## ADDENDUM No. 3

### RFP No. 25-53

#### LIBERTY STREET CREEK RESTORATION

CITY OF ANN ARBOR - PUBLIC SERVICES - ENGINEERING		PROJECT DETAILS	
SCALE NOT TO SCALE DRAWING No.	SHEET No.	SCALE NOT TO SCALE DRAWING No.	19

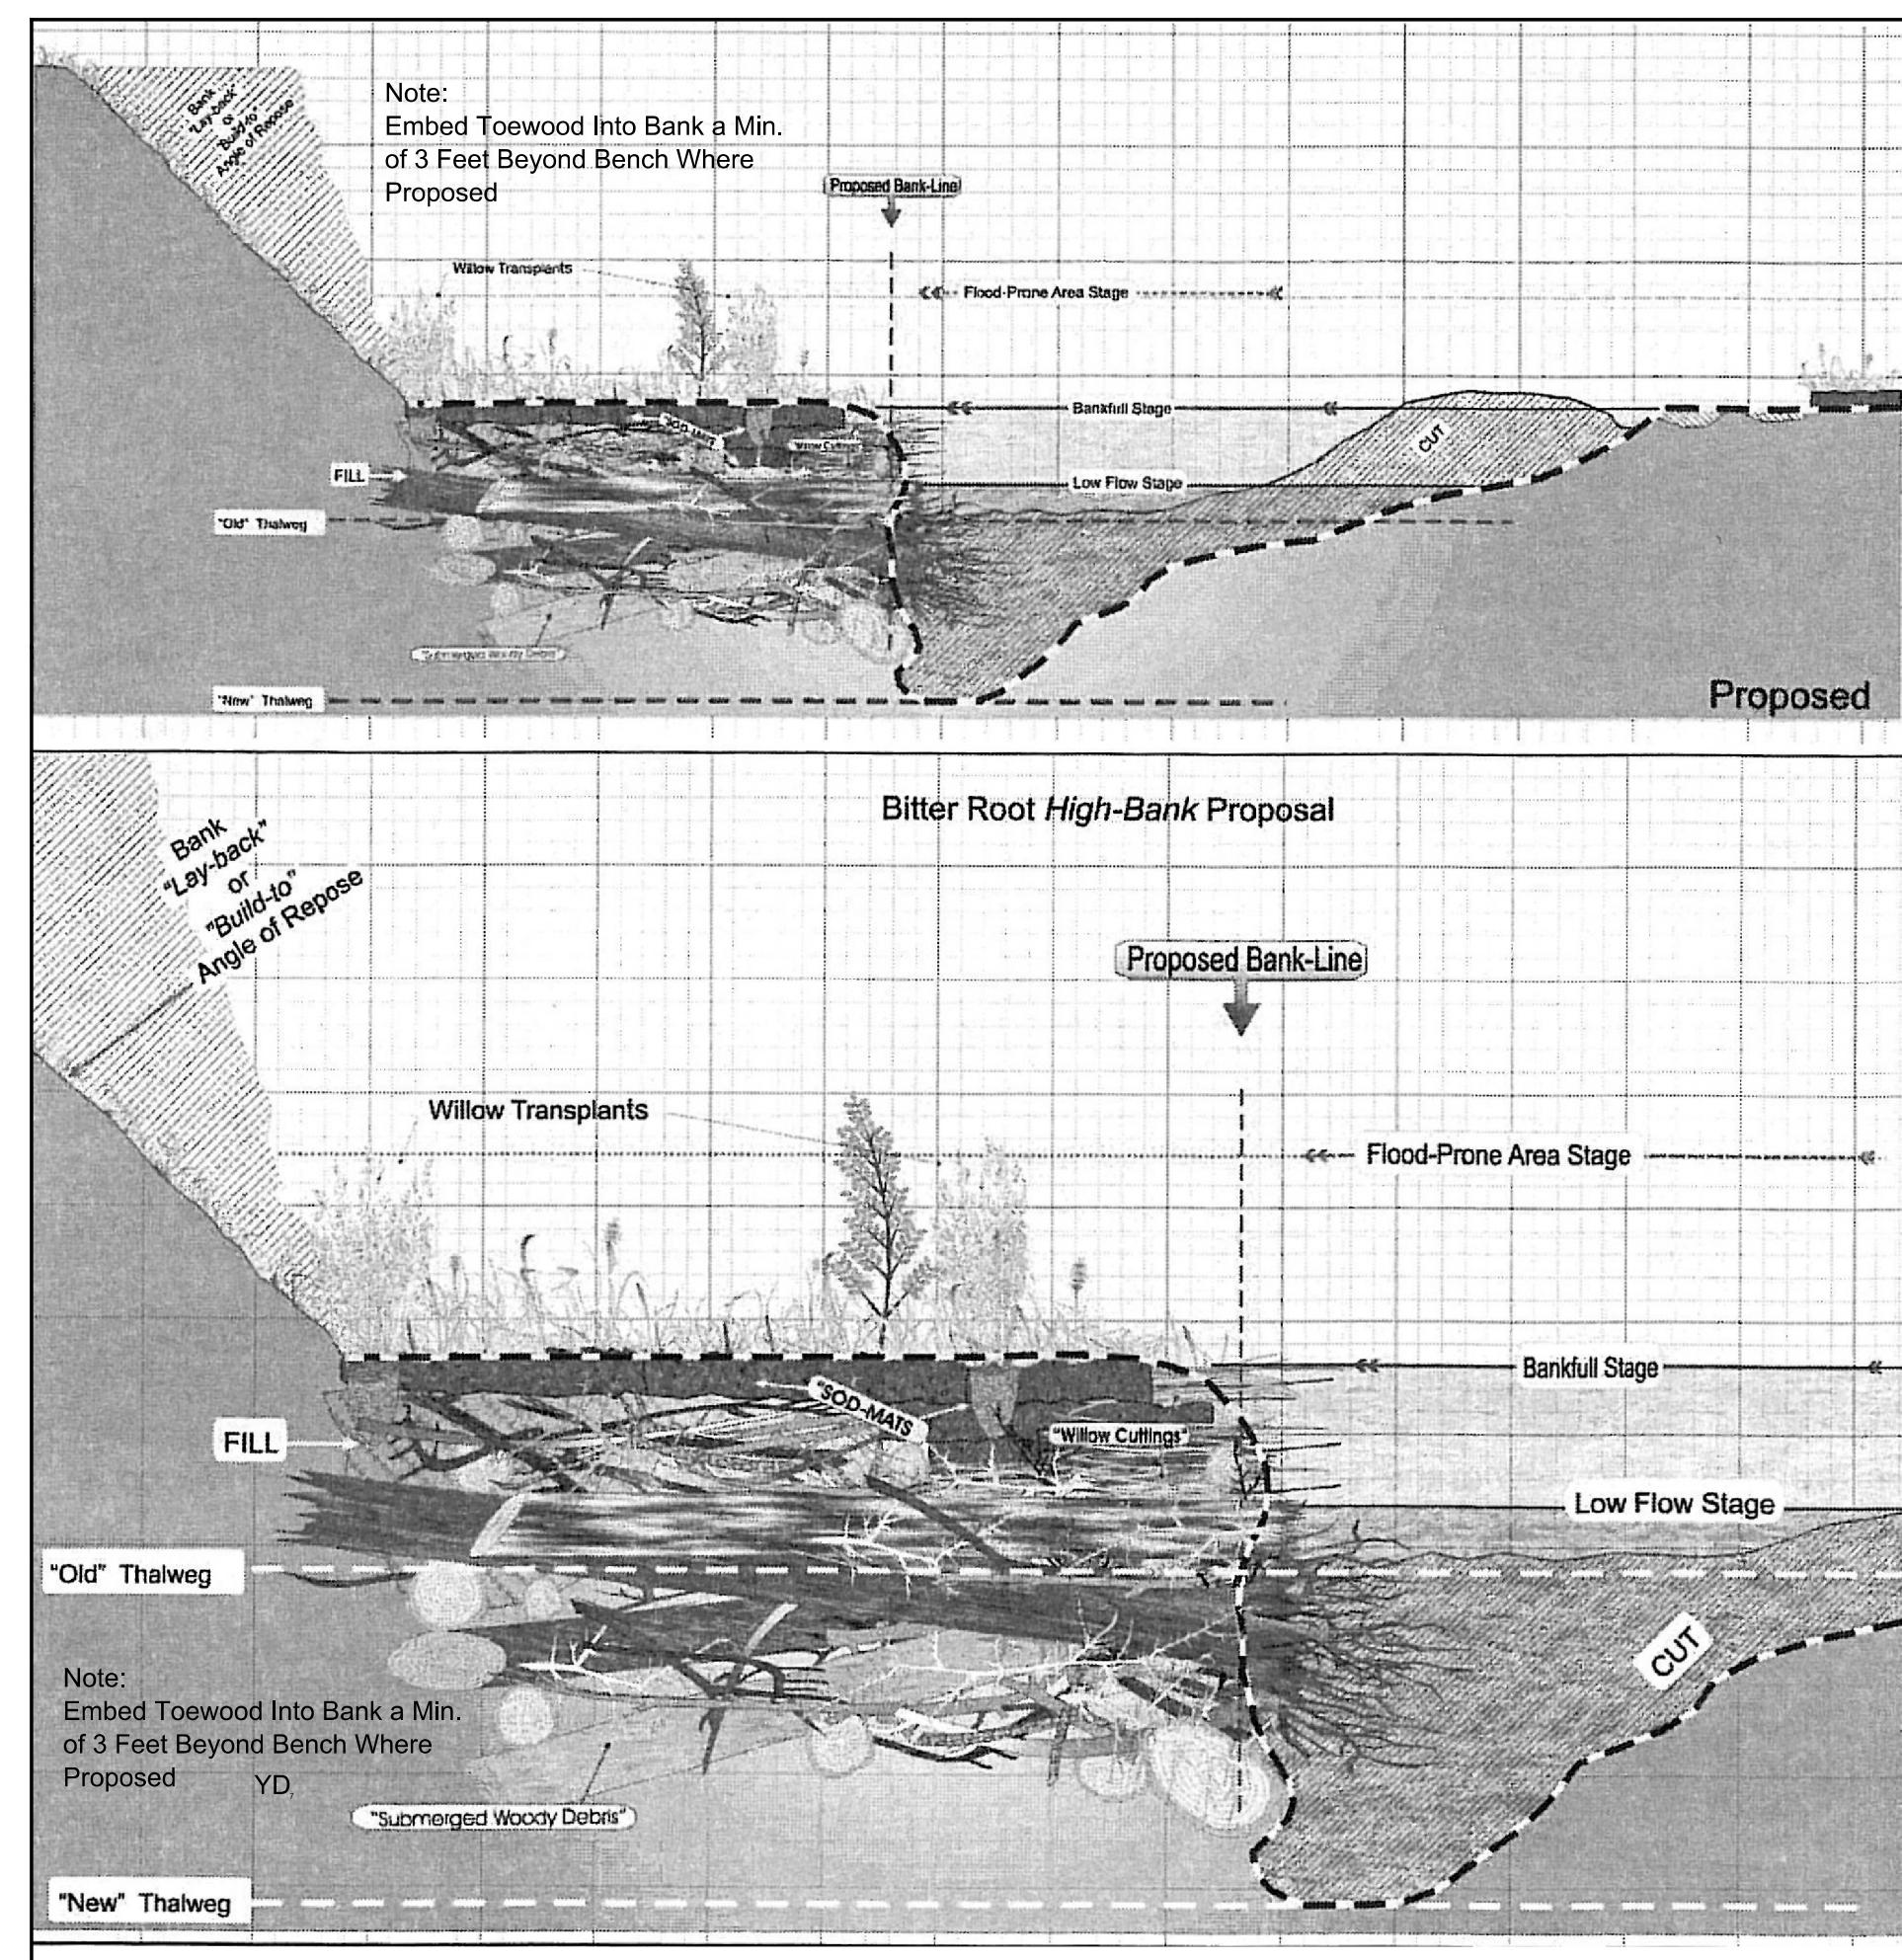
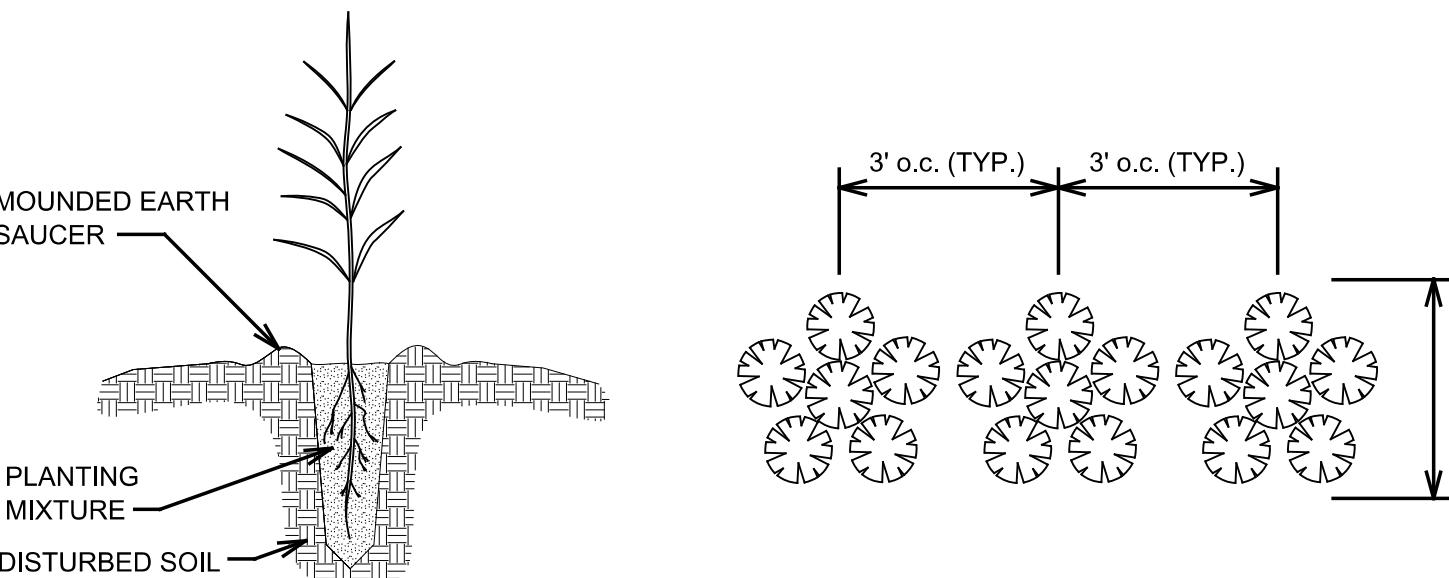
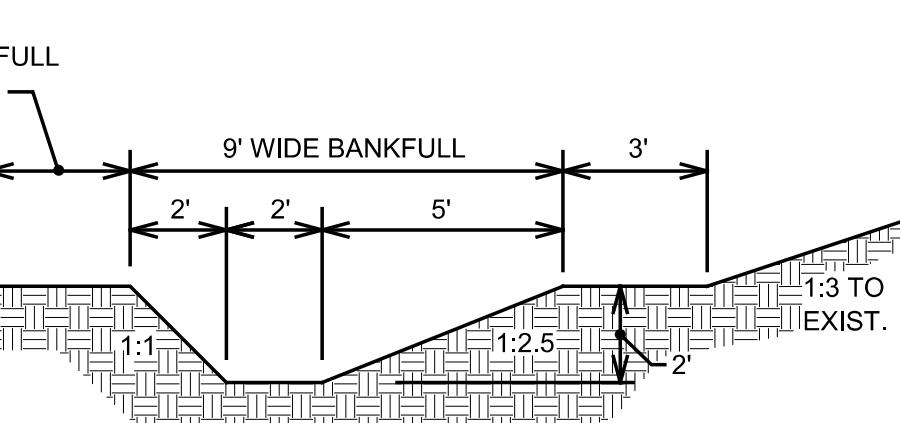
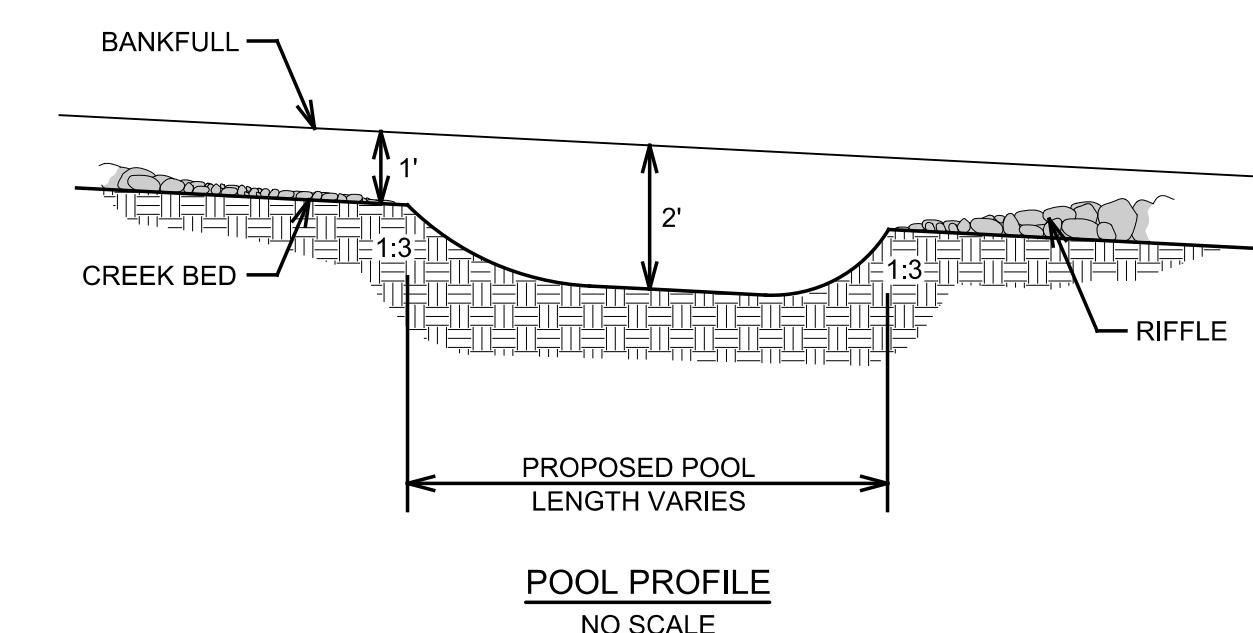
Sheet 19 – Project Details:

- Added notes to see Detailed Specifications for seeding and stabilization, and for native plant plugs.

1. SEE "DETAILED SPECIFICATION FOR RESTORATION" FOR ALL SEED MIX LISTINGS, APPLICATION RATES AND METHODS OF STABILIZATION.
2. SEE "DETAILED SPECIFICATION FOR NATIVE PLANT PLUGS" FOR PLUG DESCRIPTION AND LISTINGS.
